Spartan Fire, LLC

Technical Service Bulletin
TSB21-570-001

APPLIES TO: This service bulletin applies to Model Year 2019 through 2022 Gladiator and Metro Star emergency response chassis cabs built between January 22, 2019 and June 21, 2021.

CONDITION: Visible lines may appear in the 360 camera display.

FIG 2.2

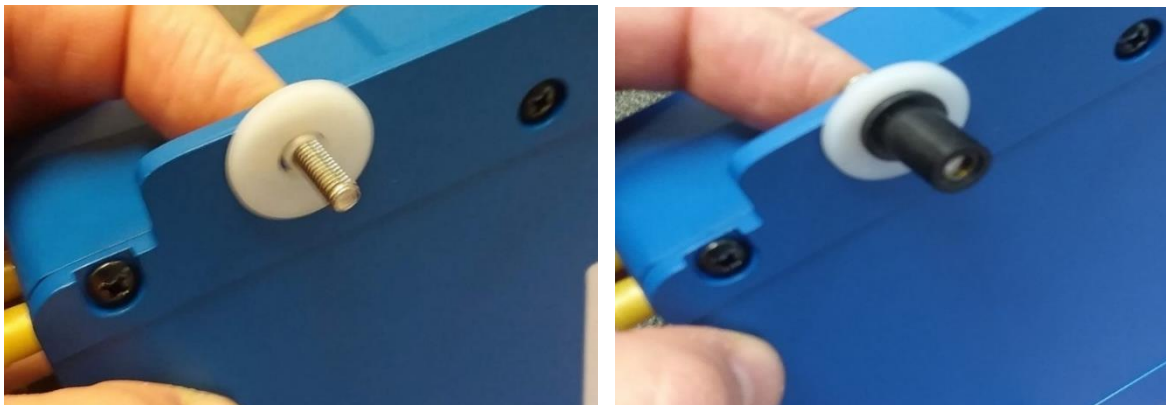
4. On bottom side of ECU flange, install a large nylon washer and a rubber well nut on each fastener. *See Figure 2.2*

FIG 3.1

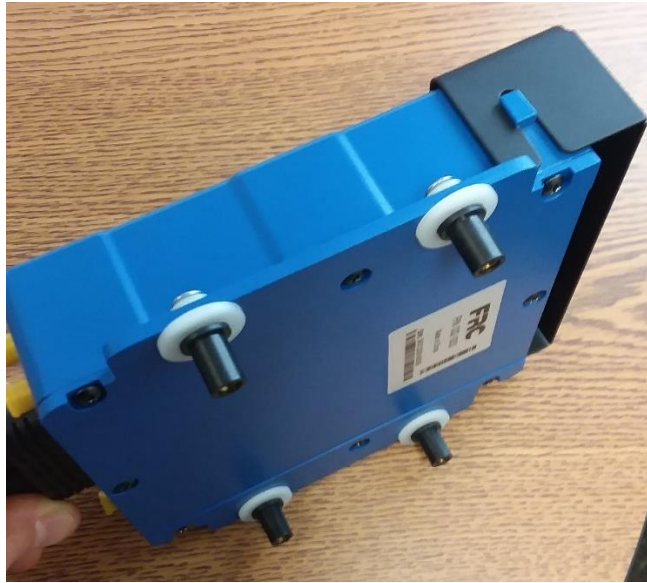
5. Drill out original mounting holes to 5/16 inch to accept the new rubber well nuts.
6. Install assembled FRC ECU with nylon shoulder washers, rubber well nuts and isolation washers and hand tighten screws. *See Figure 3.1*

FIG 3.2

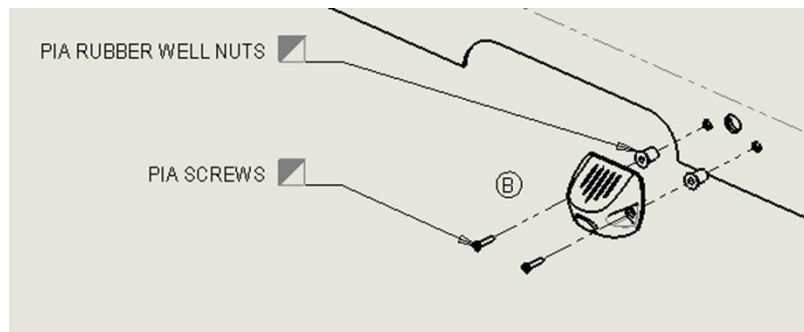
7. Locate FRC 360 front, rear and both side cameras and install rubber well nuts.
Note: Nylon shoulder washers not used on cameras. See Figure 3.2

FIG. 4.1

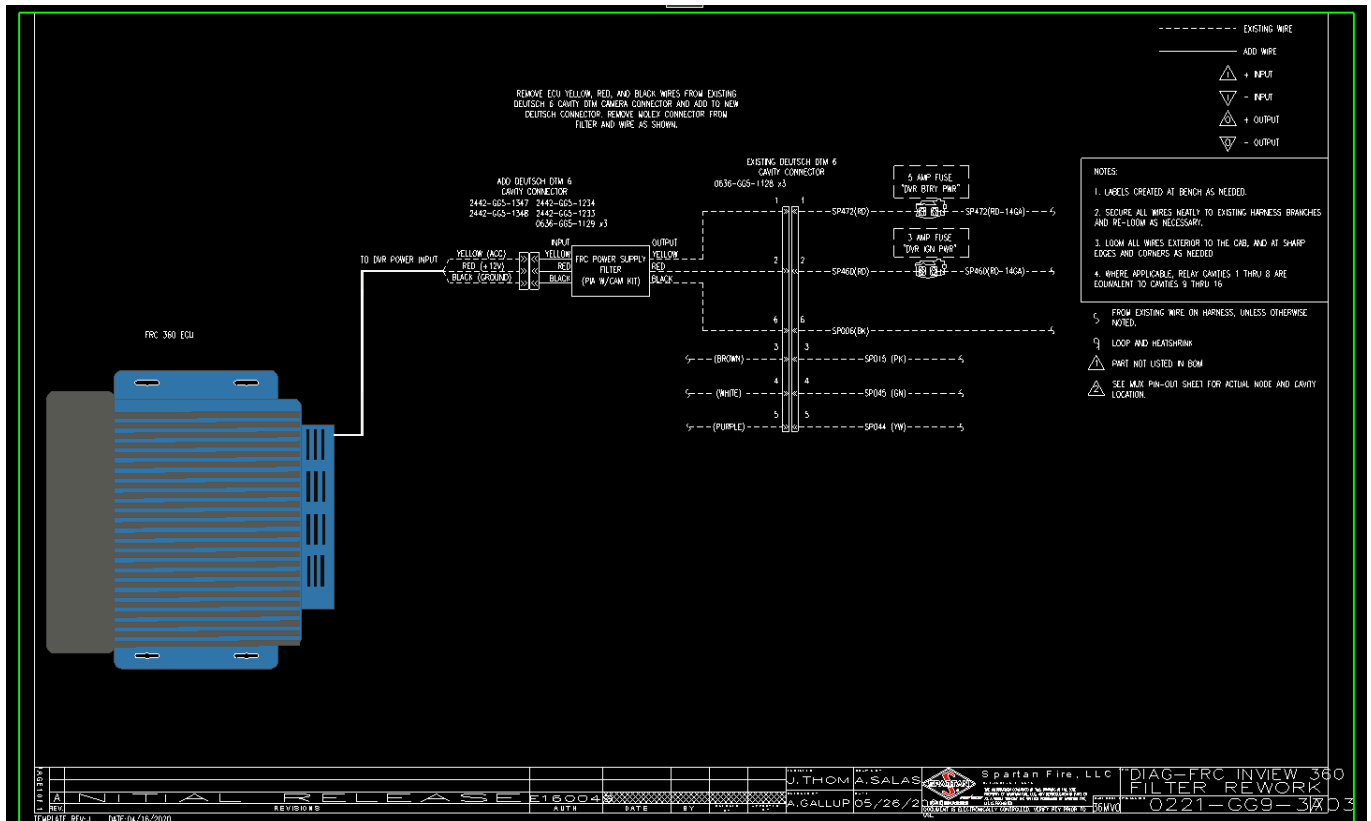
8. Locate 6 cavity connector at FRC 360 ECU and disconnect.
9. Remove yellow, red, and black wires from existing 6 cavity DTM camera connector.
10. Install FRC Power Supply Filter (from kit #4887-NN2-009) using the deutsch connector and terminals as shown in Figure 4.1.
